PUBLIC HEARING MEMORANDUM

PETITION #08-23

41 Washington Street

Application #08-23- 41 TusNua LLC, requesting a Comprehensive Permit, pursuant to M.G.L. Chapter 40B, to construct a 16-unit residential unit development on a 25,902 square foot lot located at **41 Washington Street** within a Single-Residence 3 (SR3) zoning district. ~~The proposed development would consist of reconfiguring the existing dwelling and constructing an addition.~~ The proposal includes four affordable ownership units.

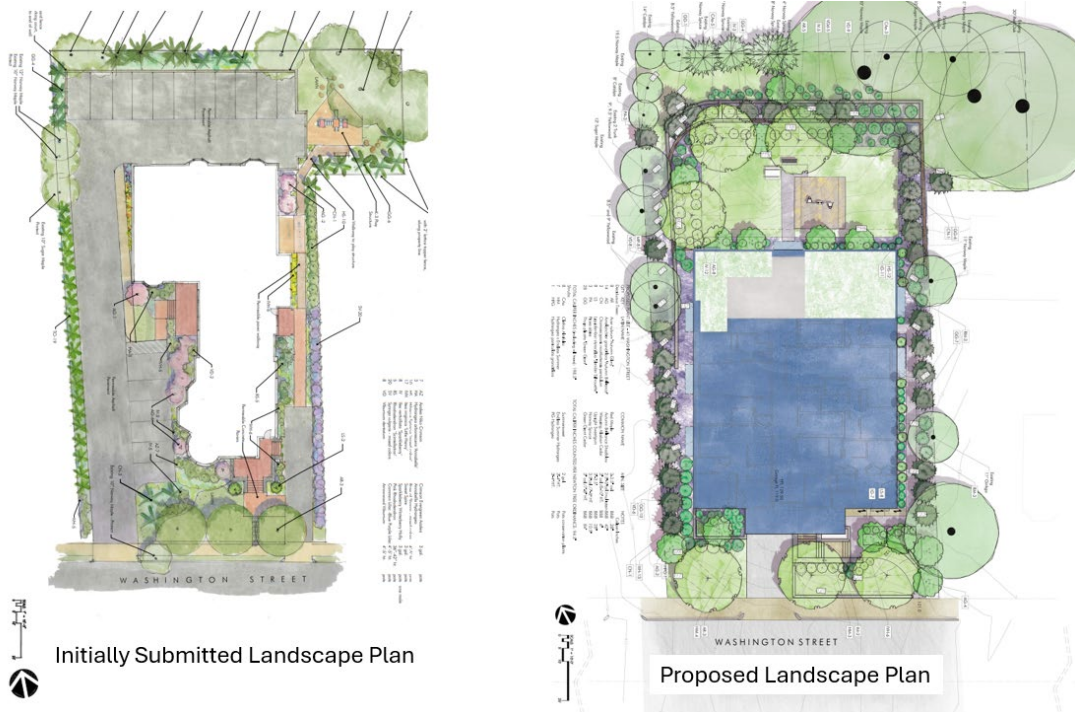
The applicant, 41 TusNUA LLC, submitted revised plans on March 8, 2024 representing a significant revision to the project. The initial iteration consisted of reconfiguring the existing two-family home into four units and constructing a four-story addition with twelve units to the rear of the dwelling, resulting in a 16-unit multi-family dwelling. The revised plans consist of demolishing the existing two-family dwelling and new construction of 16 units and all parking within the first floor of the proposed building.

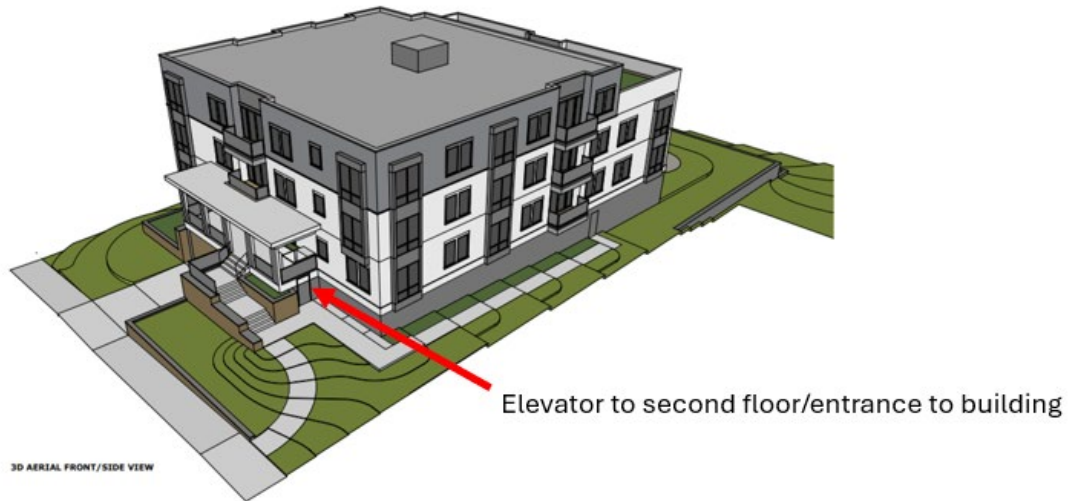
pervious area and vegetation on the site, while allowing more screening along the property lines. These changes are most legible via a landscape plan, shown below.

The rear yard is proposed to be left as open space, which is a significant improvement over the previously proposed parking and hardscape, which only maintained an 8–10-foot setback from the rear lot line. To create a level rear yard, the applicant proposes two terraced retaining walls, six feet apart, that reach a cumulative height of approximately 7.8 feet. They are outside of the 15-foot rear setback, thus do not require zoning relief. The applicant is proposing screening along all lot lines and is not proposing anything on the portion of the lot that juts out at the northeast corner, which will provide an additional buffer and distance from the project for the neighbors on Elmhurst Road to the east.
